Service Bulletin

No. : MZ08-035

Model: ES7001

Subject: Improvement of FUSE (F802)

POS NO. R808, L804 (SECONDARY POWER PWB P802)

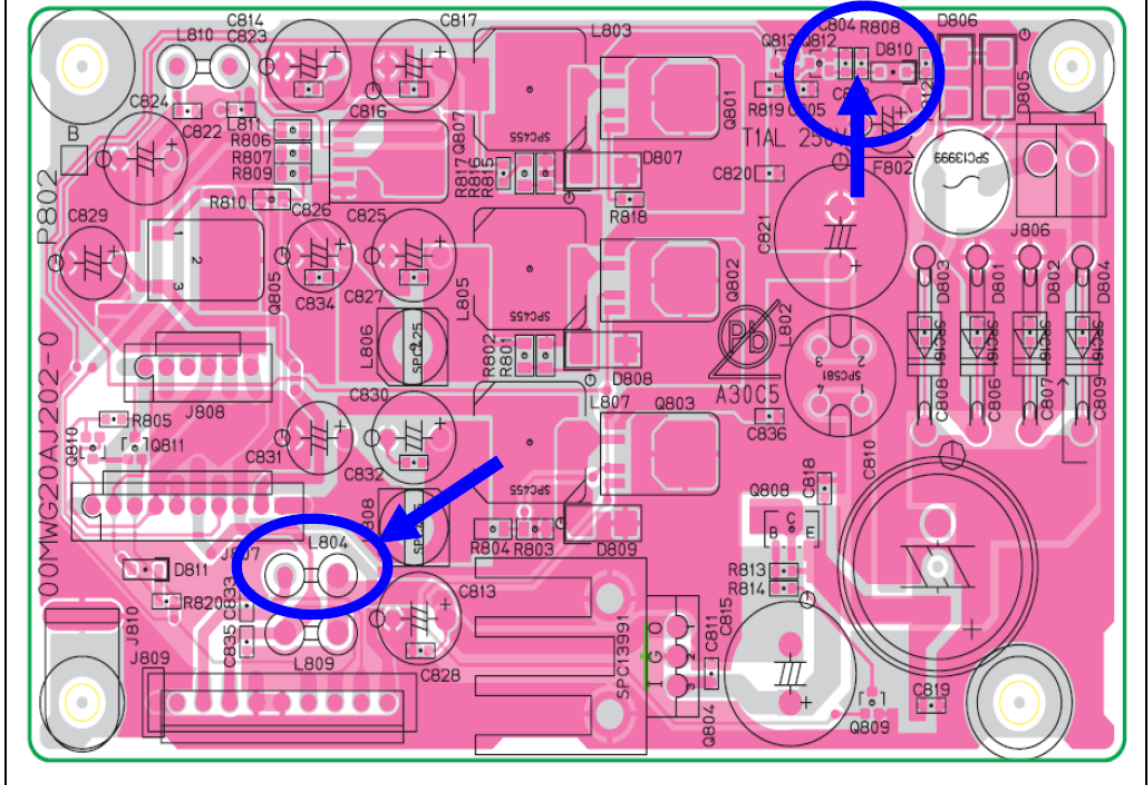
Symptom: The fuse (F802) may open when the AC rated voltage goes down to -10% or lower while the unit is connected via HDMI.

Solution: The circuit must be modified to detect voltage sags sooner, put the unit into standby or mute, reduce actuating currents and thereby prevent the fuse from opening.

1. The 18k Ω on **POS NO. R808** (SECONDARY POWER PWB P802) with a **10k Ω** resistor.
2. The FERRITE CORE on **POS NO. L804** (SECONDARY POWER PWB P802) with a **10 Ω** resistor.
3. The 100u/16V on **POS NO. CP40** (DIGITAL AMP PWB PP01) with a **2,200u/16V** capacitor.
